LATEST REVISION DATE 09-14	
	STANDARD DESIGN - 30' ROADWAY, SINGLE SPAN BRIDGE <b>PRETENSIONED PRESTRESSED CONCRETE BEAM BRIDGES</b> APRIL, 2012
	<b>WING ARMORING DETAILS</b> C & D BEAMS
APPROVED BY BRIDGE ENGINEER 	<b>H30S1-42-12</b>

**TOP VIEW OF WING ARMORING WITH WING EXTENSION**

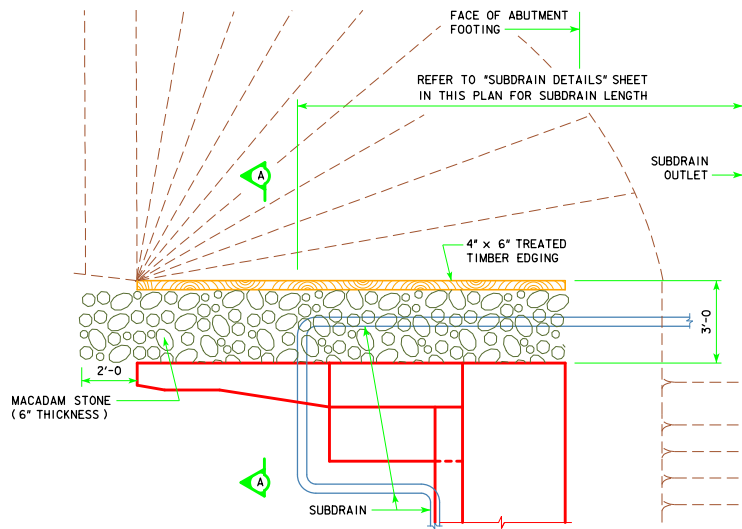
REVISED 09-14 - THE MACADAM STONE AREA WAS MODIFIED TO EXTEND 2 FEET IN FRONT OF THE BRIDGE WING.
